**MARINE AND COASTAL ACCESS ACT (2008). APPLICATION FOR THE TEES SOUTH BANK DEVELOPMENT PHASES 1 AND 2 BY THE TEES SOUTH BANK CORPORATION (TSBC) AT RIVER TEES, MIDDLESBOROUGH.**

Reference Number: MLA/2020/00506 (MLA/2020/00507)

From: Joe Perry  
Cefas, Lowestoft Laboratory  
Date: 8<sup>th</sup> February 2021  
Tel: 01502 524564  
E-mail:  
[regulatory\\_assessment@cefass.co.uk](mailto:regulatory_assessment@cefass.co.uk)

Figure 1. Barchart detailing annual volumes disposed at Tees Bay C (TY150) from 1988 - 2019. Units are in metric wet tonnes. OSPAR data are not yet available for 2020.

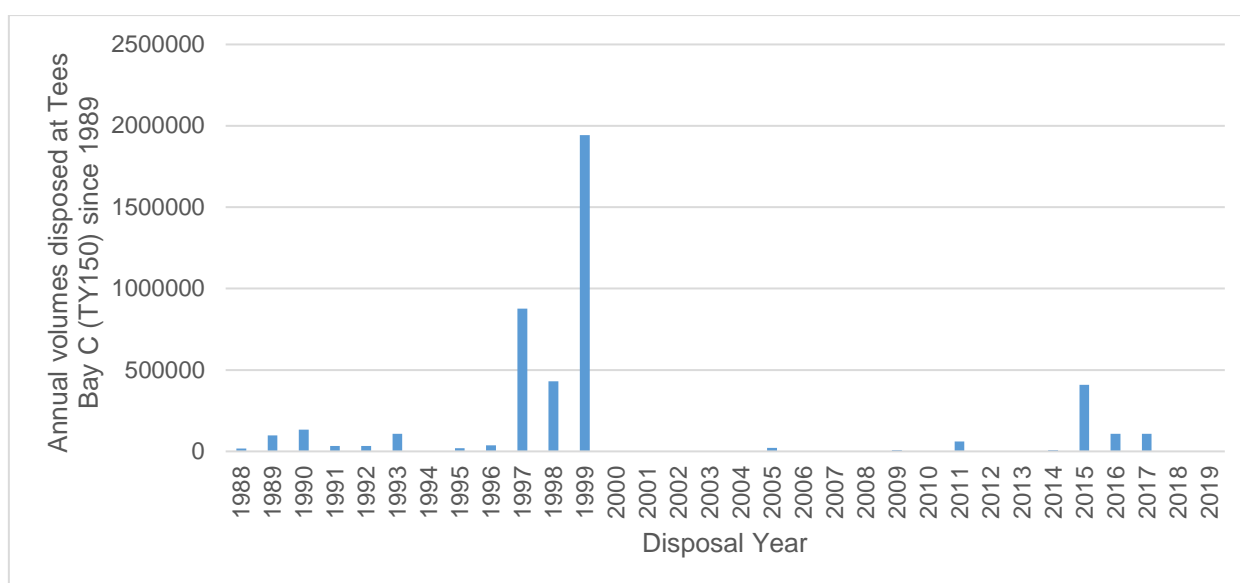
11. This is a fairly accurate characterisation of the site, though it is unclear what “DEFRA records” refer to. Figure 1 of this advice minute provides an overview of annual volumes disposed at Tees Bay C (TY150) from 1988 to 2019 according to available OSPAR returns data.

12. As indicated by Figure 1, Tees Bay C (TY150) has indeed received smallscale usage up to a maximum of 1.9 million wet tonnes in 1999. The data indicate that the proposed disposal volume is similar to the maximum annual volume received by the site, however, the length of time that has passed since the site received volumes of this magnitude should be acknowledged. There may be uncertainty concerning the likely effects on the surrounding environment from a disposal of similar magnitude, particularly given the relatively low volumes it has received in the last 20 years.

27. 6.37 M wet tonnes is more than three times larger than the largest volume received by Tees Bay C (TY150). This is further compounded by the fact that the largest volume (1.9 M wet tonnes) was deposited at the site over 20 years ago. The question as to the capacity to receive disposed sediment of Tees Bay C (TY150) cannot be answered in this consultation, and would likely require sediment and plume dispersal modelling as part of a cumulative impact assessment.
